Coshocton Port Authority
Coshocton Collaborative

Addendum No. 1 – 19.137

December 4th 2023

1 FP2.1 **BASEMENT FIRE PROTECTION PLAN**
1/8" = 1'-0"

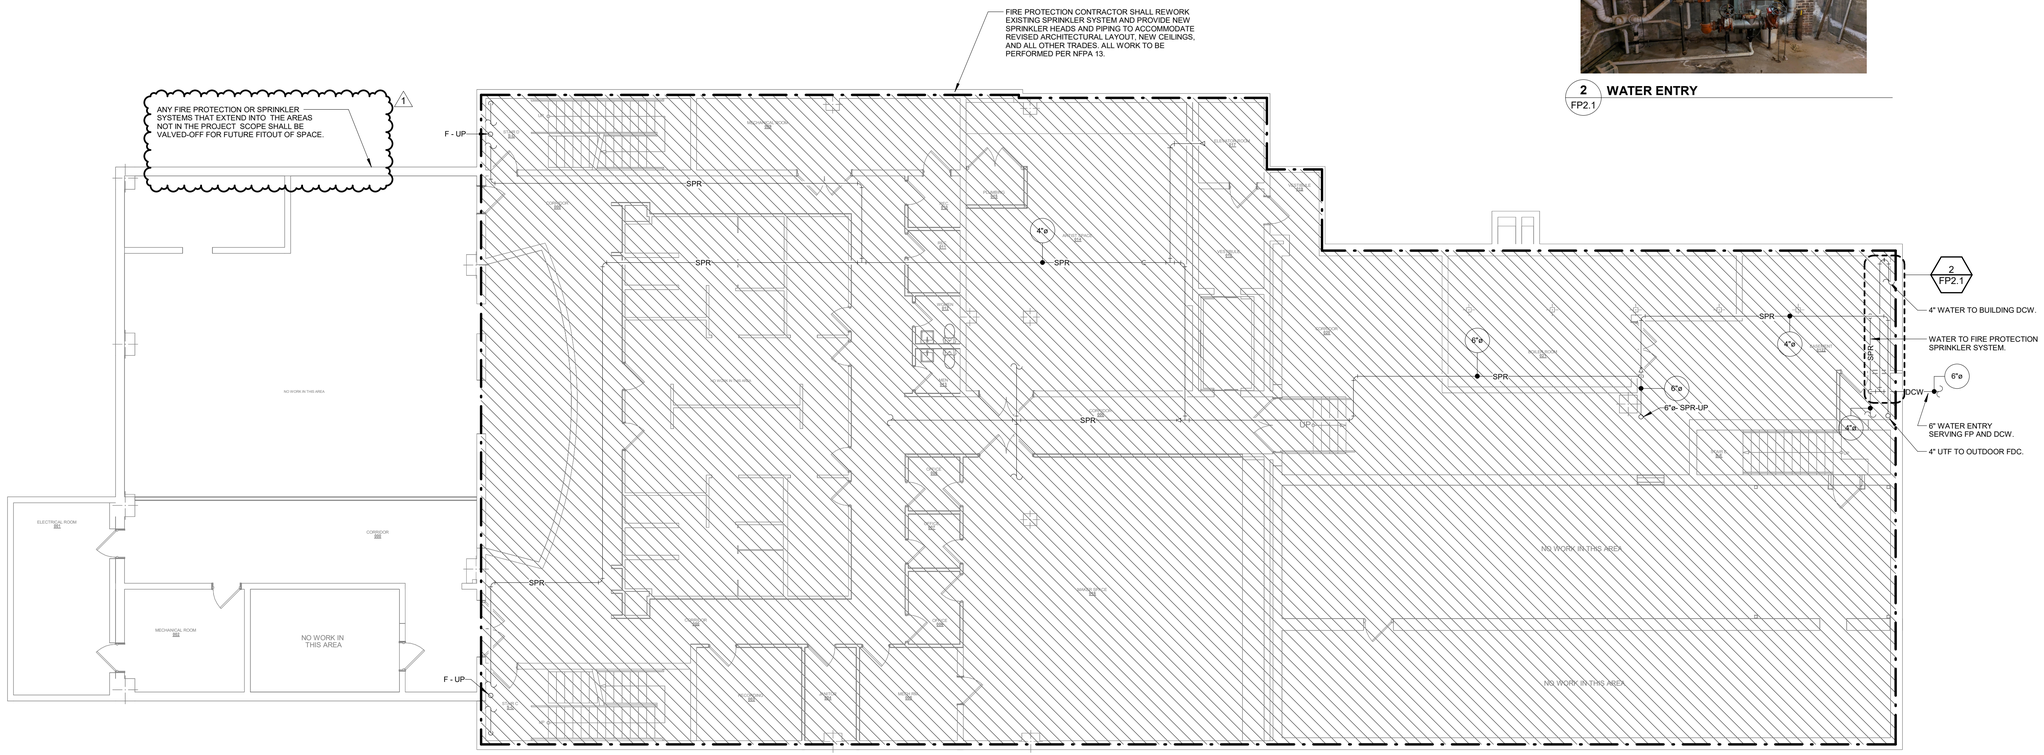
3. What are we to do with the system in the areas of "NO WORK"? There is piping ran in all these areas.
   Any sprinkler/fire protection mains that are extended to the areas not included in the scope shall have a valve installed to close-off the downstream system for fitout under a future phase. Additional notation will be added under Addendum #1.

ANY FIRE PROTECTION OR SPRINKLER SYSTEMS THAT EXTEND TO SERVE THE AREAS NOT IN THE PROJECT SCOPE SHALL BE VALVED-OFF FOR FUTURE FITOUT OF SPACE.
